Software 06.10.00.04 version

The changes introduced in the software version 06.10.00.04 are the follows:

SERVICE

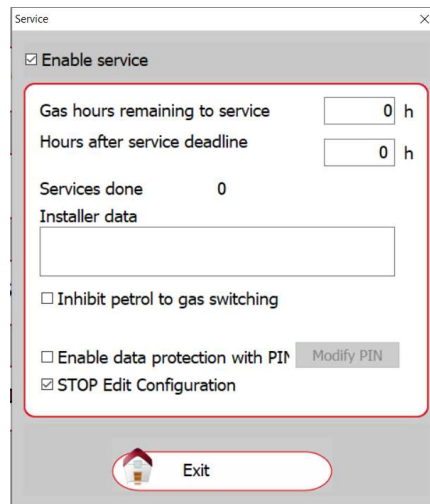
When you connect to an ECU unit with the latest firmware version loaded, the SERVICE icon appears.

Clicking on the icon to open the SERVICE page.

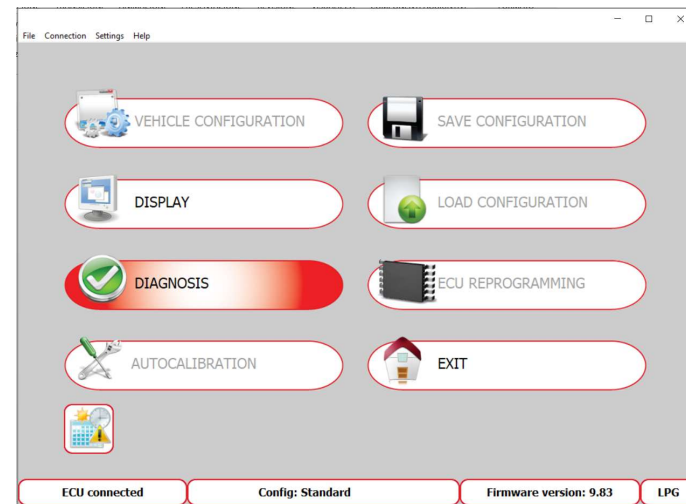
At the bottom of this page the new STOP EDIT CONFIGURATION option has been introduced.

By enabling this option, when you exit the SERVICE window, all the buttons of the MAIN MENU are inhibited except DISPLAY and DIAGNOSIS.

In this way it will not possible to make any changes to the configuration loaded in the control unit, will be only possible to view the operating parameters and enter to diagnosis page.

To re-enable the other items of the MAIN MENU it will be necessary to disable the STOP EDIT CONFIGURATION option.
